MONTGOMERY COUNTY HISTORIC PRESERVATION COMMISSION
STAFF REPORT

| Address: | 43 W. Lenox Street, Chevy Chase | Meeting Date: | 2/21/2024 |
| Case Number: | 1057144 | Staff: | Dan Bruechert |
| Proposal: | New Construction, Fenestration Alteration, Skylights, Recladding Addition, New HVAC screening, and New Deck | | |

SHEET TITLE:
 SECTIONS

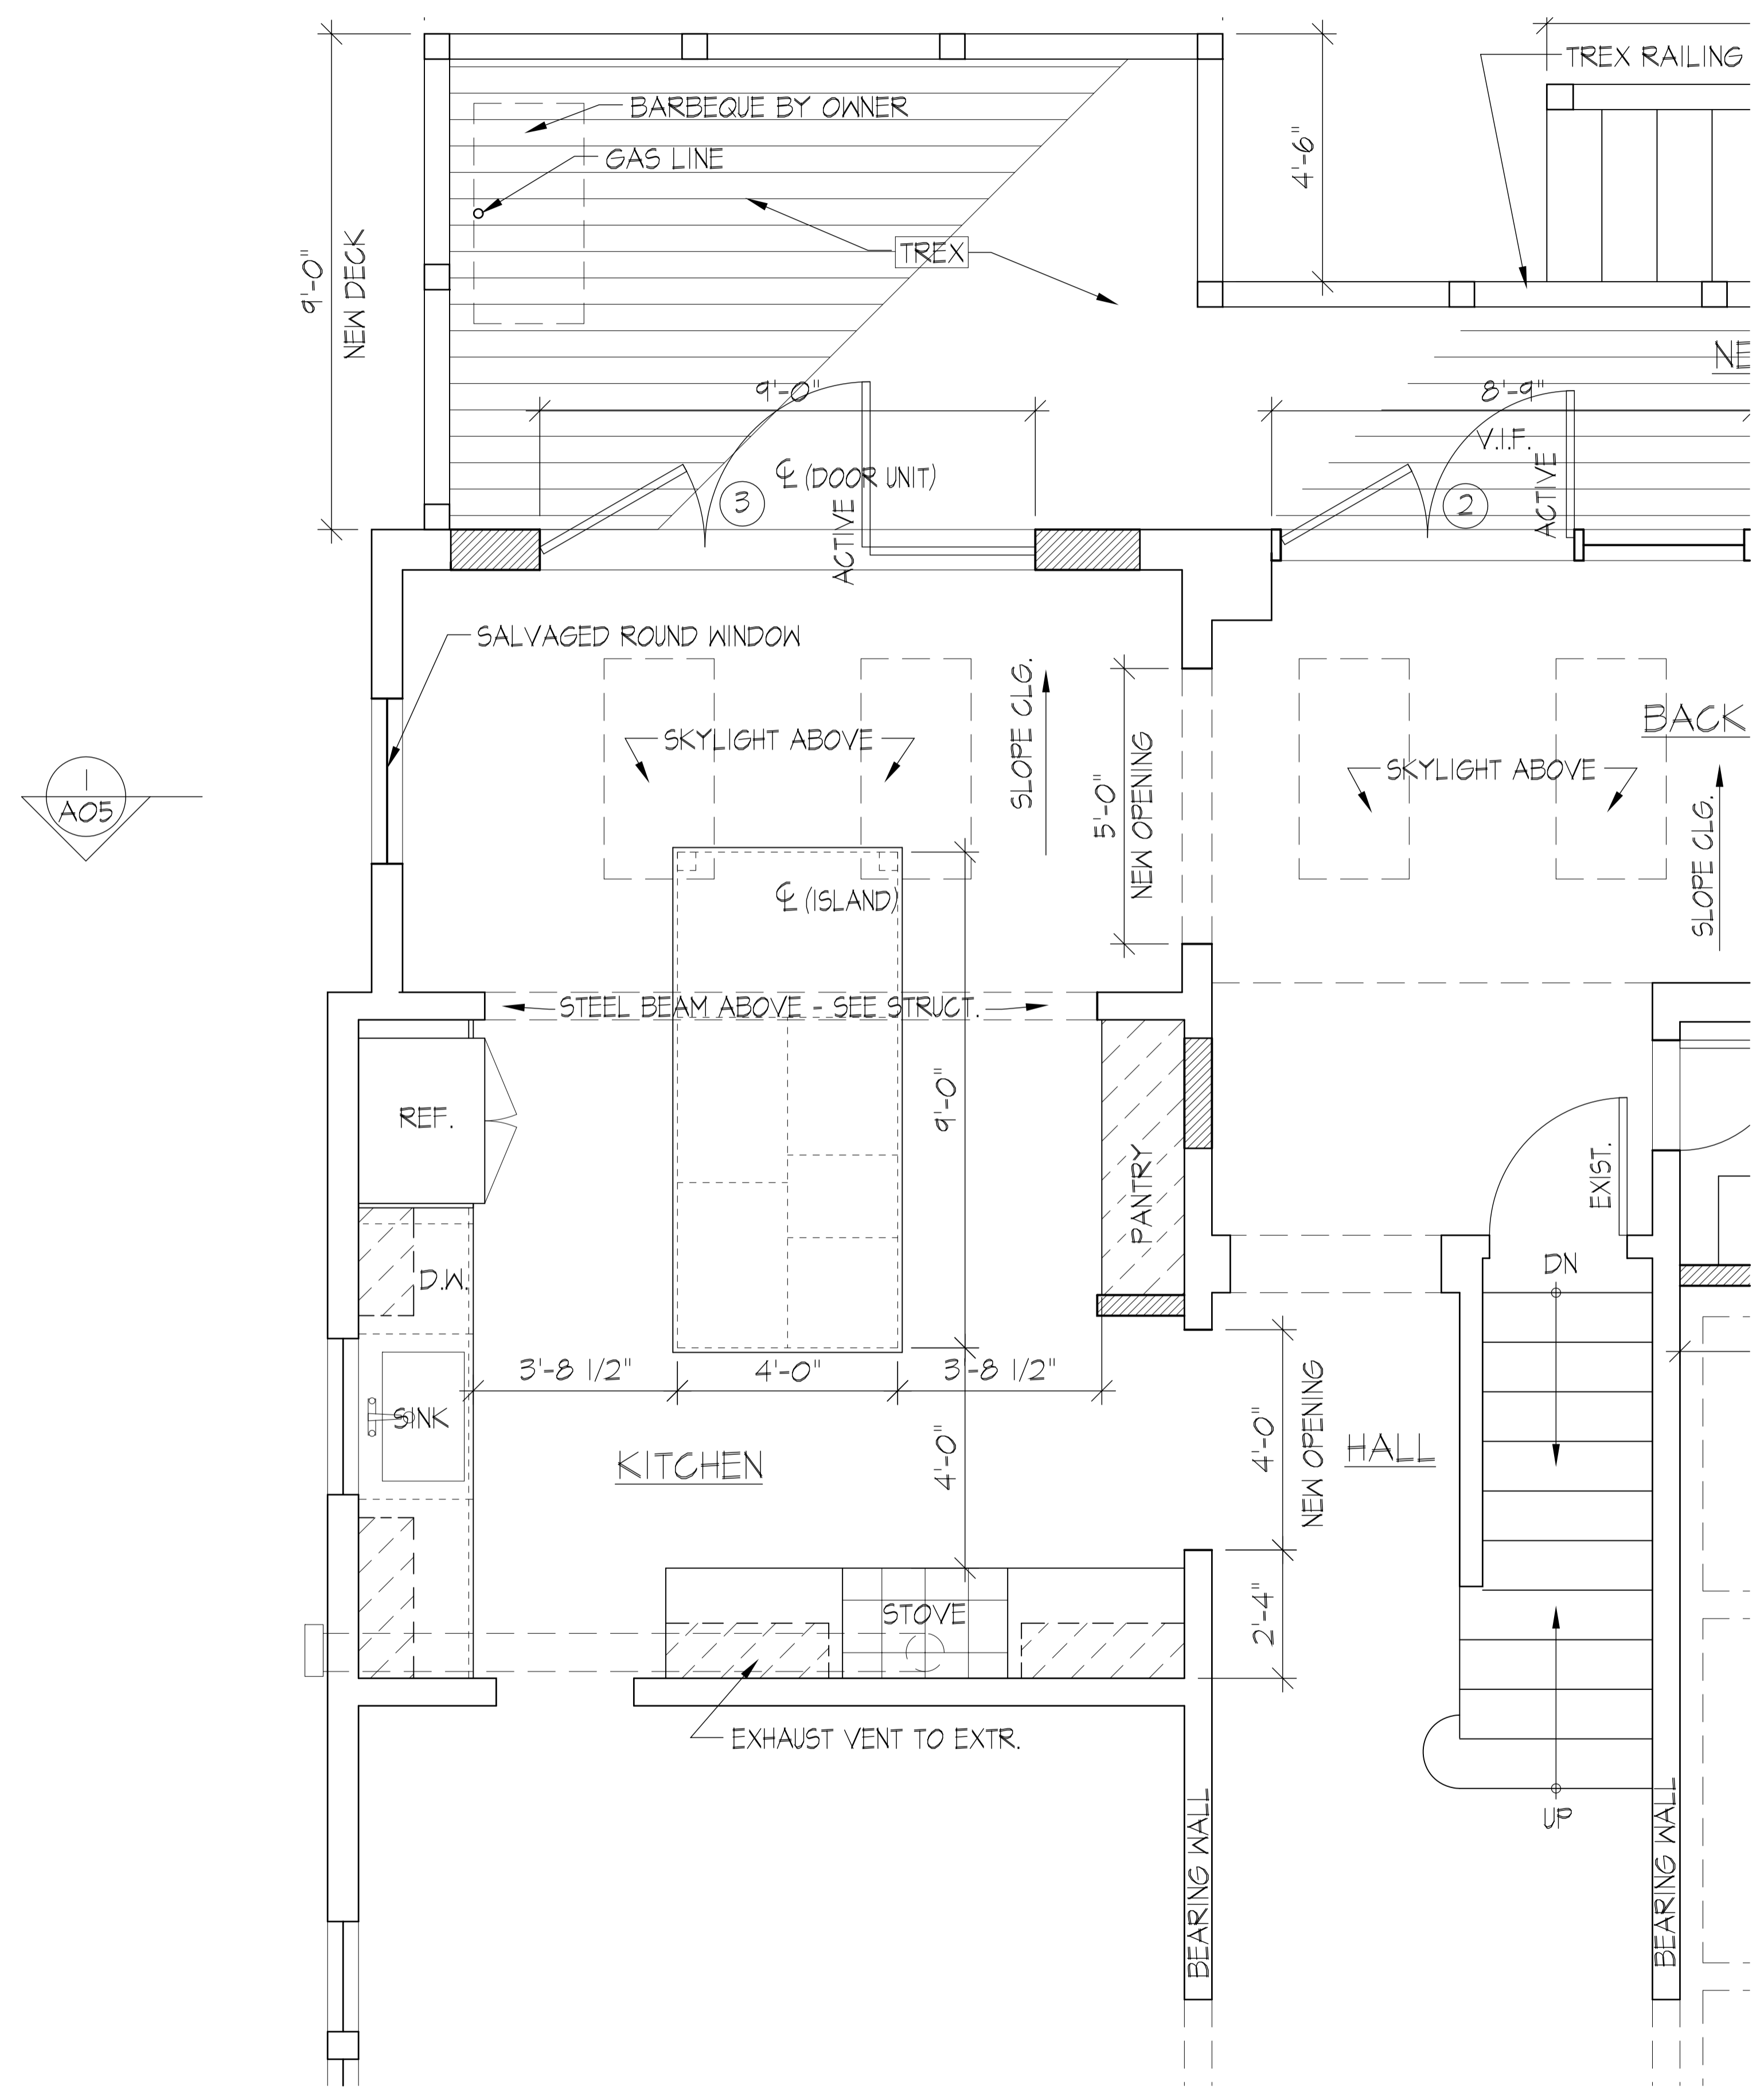
At the rear of the house, the applicant proposes to remove the existing shed roof over the non-historic addition and reconstruct it with a minor modification for a second-story deck. The reconstructed roof will include skylights. A shingle specification was not provided with the submitted material.

Staff finds that the proposal to replace the existing roof is driven by material failure and finds that its replacement will virtually match the existing. Staff finds skylights on the rear are to be reviewed under lenient scrutiny and will not have a significant impact on the character of the house.

Staff recommends two additional conditions related to the proposed rear addition roof. First, Staff notes that a roofing specification was not provided with the submitted materials. Because Staff finds either an architectural shingle or three-tab shingles would be appropriate, Staff recommends the HPC delegate final approval authority to Staff to verify an appropriate shingle be submitted with the final material specifications. The second condition is related to the railing for the proposed second-story deck. The drawing notes the railing will be Trex but does not identify a specific line or design. Staff cannot provide any feedback on the design and does not find Trex to be a compatible material and recommends the HPC delegate final approval authority to Staff to ensure the final railing is a compatible design and material. This railing needs to satisfy the requirements of the condition for the deck railing discussed above.

2. A final shingle specification for either an architectural or three-tab shingle shall be submitted to Staff for review and approval before final issuance of the HAWP.

5. Specifications for a second-floor railing consistent in design and materials with Condition 1 shall be submitted for review and approval before issuance of the HAWP. Final approval authority for the railing material and design is delegated to Staff.
